Bid Bulletin #02

PROJECT: Gateway Early Childhood Center
Bid Package #4
Omaha, NE

ADDENDUM E

Gateway Early Childhood Center
Omaha, Nebraska
RDG Project No. 2014.129.00, File 35.1

Project Number: 2014.129.00	Date: 12/03/14	Add to Sheet: A05.01	Drawing: SDA-024
	ADD E		GATEWAY EARLY CHILDHOOD CENTER

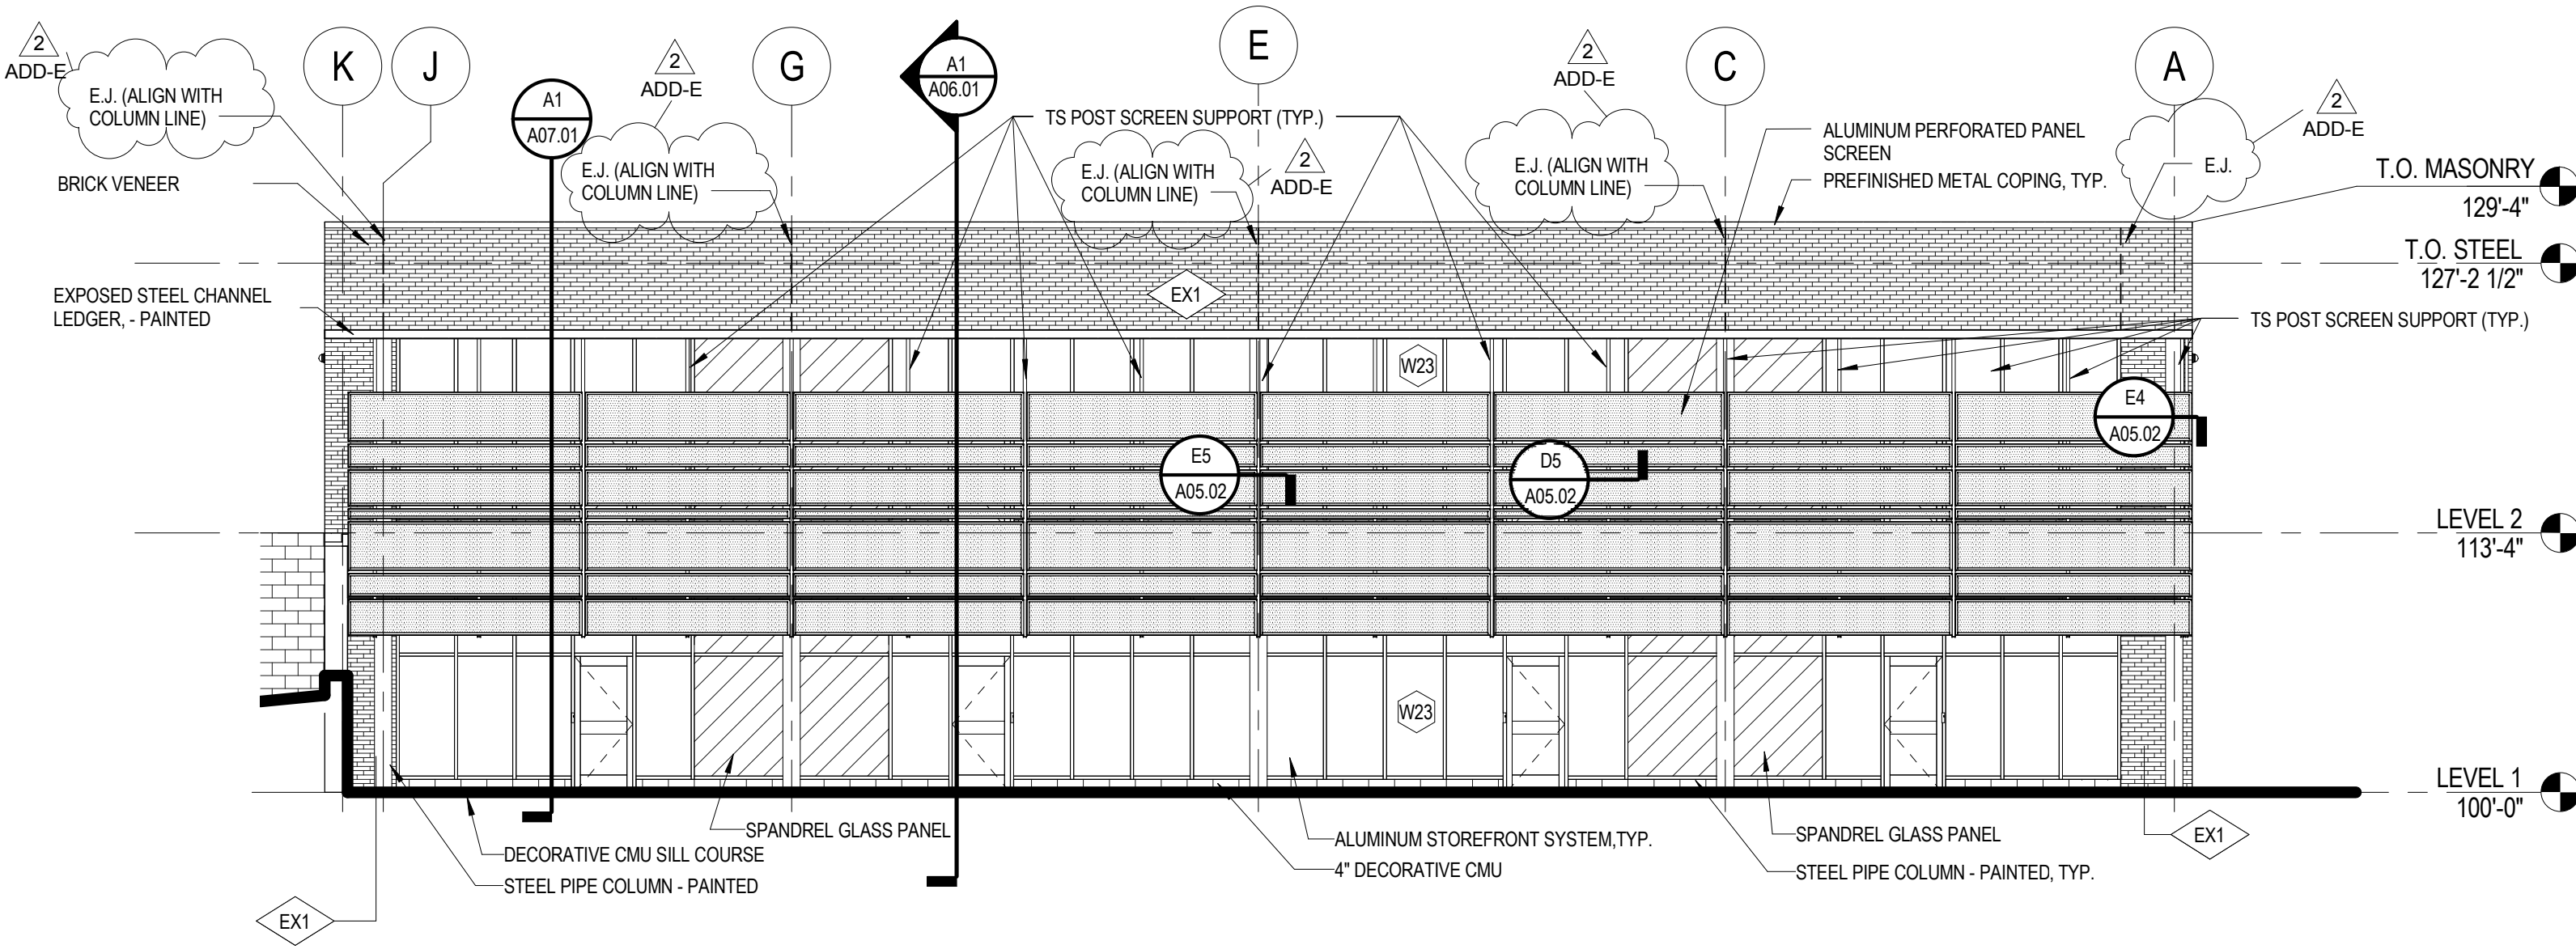
- A. A2 – “South Elevation,” Two W5 Windows Located between Column Lines 1 and 2:
 - 1. Modify window tag from W5 to **“W30.”**
 - 2. Modify height of these windows from 1’-4” to **2’-0”**.
 - 3. Modify height above finish floor of these windows to **1’-4”**.
- B. B2 – “North Elevation,” W5 Window Located between Column Lines 1 and 2:
 - 1. Modify window tag from W5 to **“W30.”**
 - 2. Modify height of this window from 1’-4” to **2’-0”**.
 - 3. Modify height above finish floor of this window to **1’-4”**.
- C. D4 – “West Elevation:” Brick veneer expansion joints indicated.

EXTERIOR GREASE INTERCEPTOR

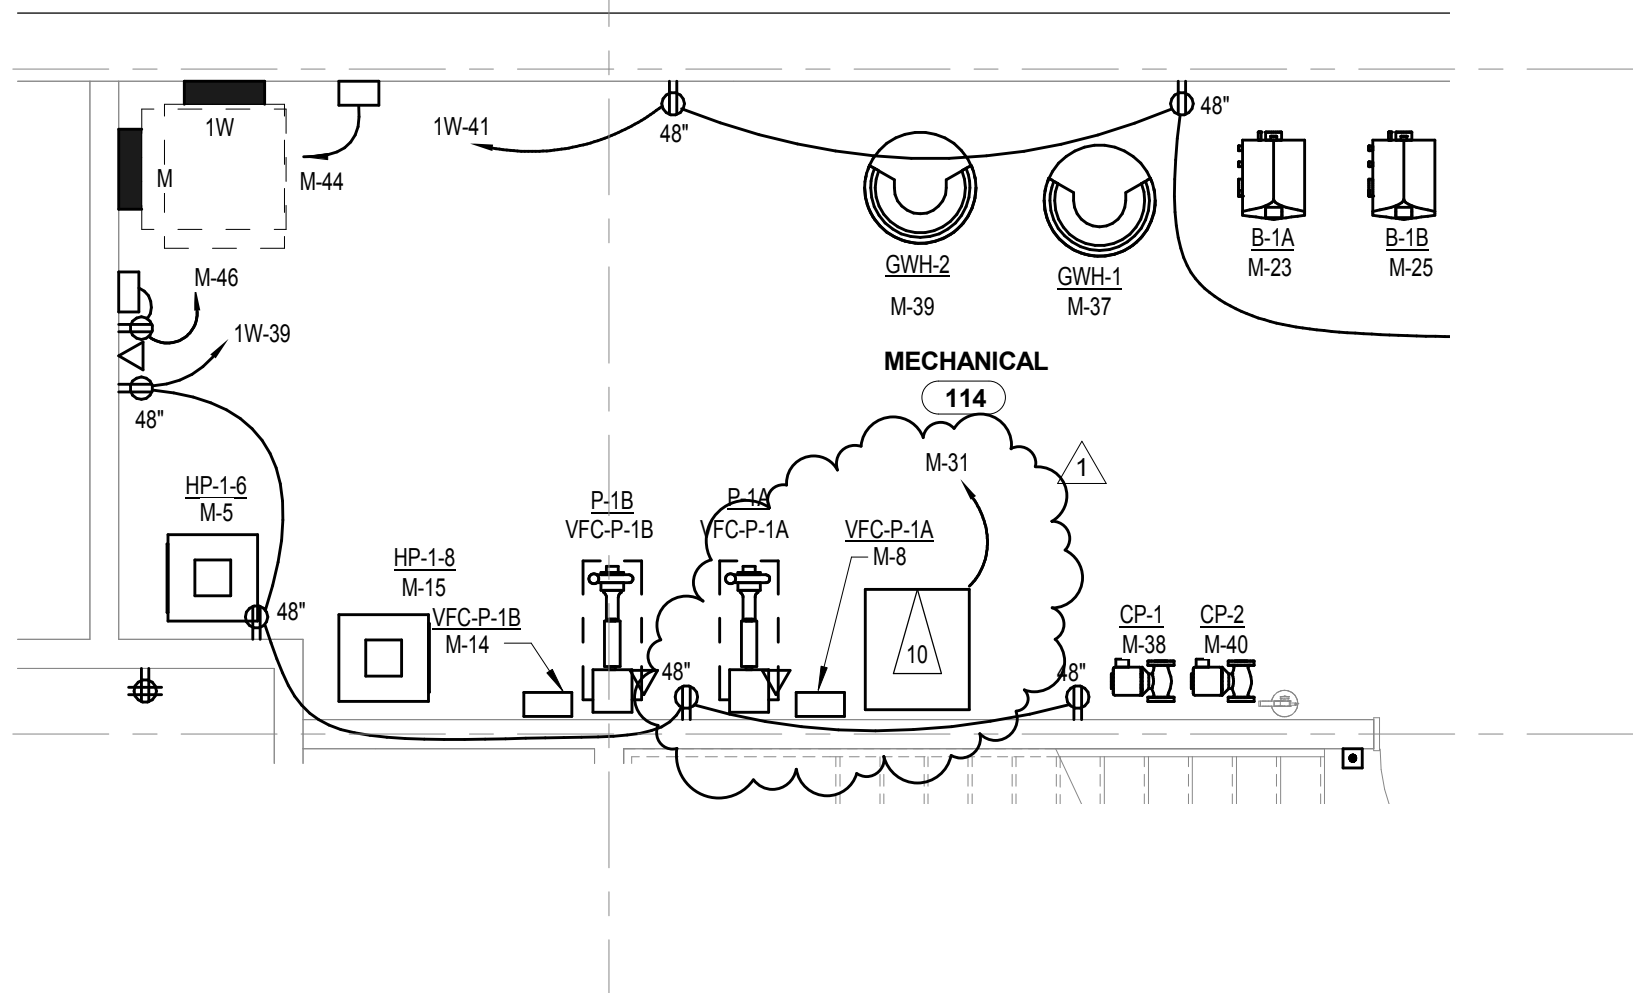
Sheet P4.0 – Plumbing Details, Detail 6/P4.0 – Exterior Grease Interceptor: Modify detail to include sizing information. See revisions as indicated on attached Mechanical Sketch Sheet SDP-002.
